ADMIN BUILDING

N/A  
ORANGETOWN  
23 KINGS HWY  
ORANGEBURG, NY 10962

EXTERIOR SIGNAGE SUBMITTAL

28142  
2023-05-05

SHEET TITLE  
STREET/CONTEXT PHOTOS

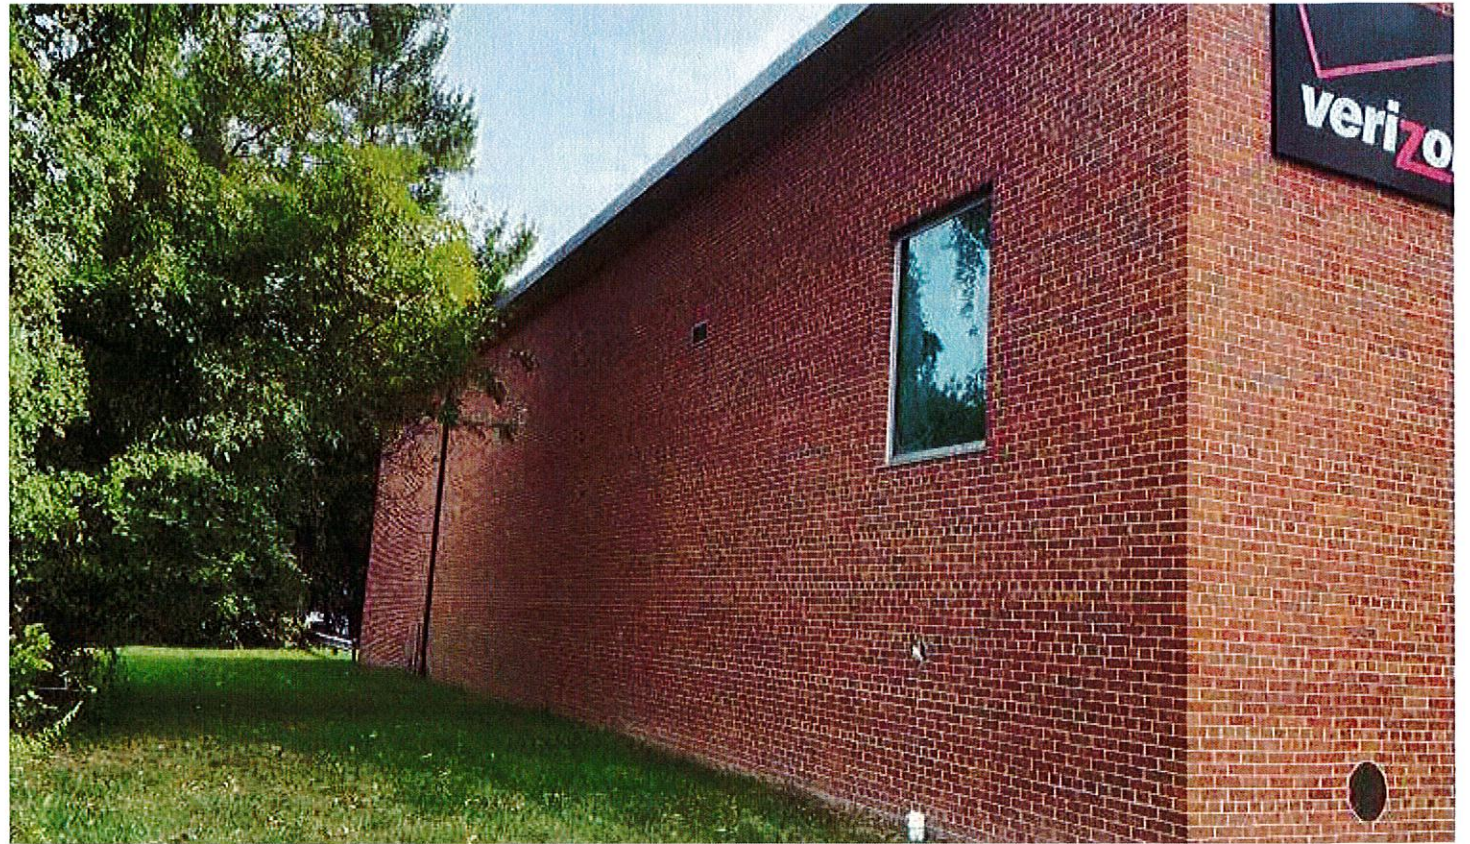
Survey needed for regulatory sign

OUTLET ID OR #	ADDRESS	SHEET TITLE	DATE	Agent Name	PREPARED BY	SHEET NUMBER
ORANGETOWN PROJ #28142	23 KINGS HWY ORANGEBURG, NY 10962	SIGN 1 - WEST ELEVATION - WALL SIGN - RENDERING	2023.05.05 REV 0 IDV	ADMIN BUILDING	IDENTITI	5

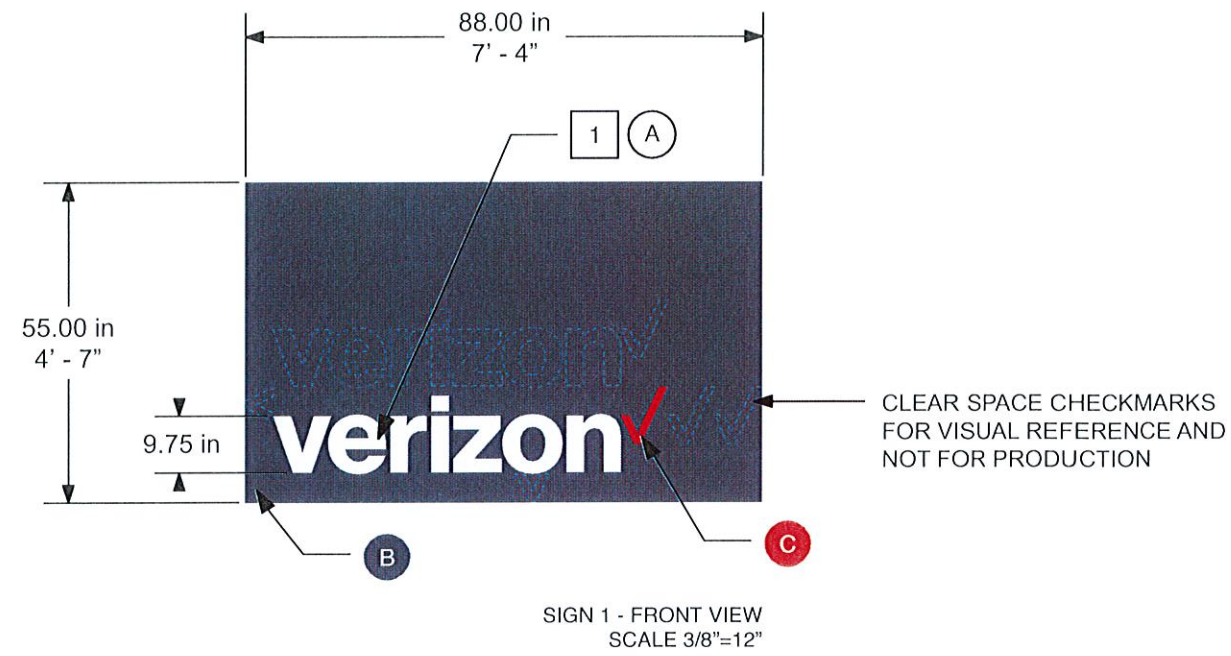
- \*No wall repair needed - to be installed in exact location
- \*Hardware to be painted Cool Gray 10
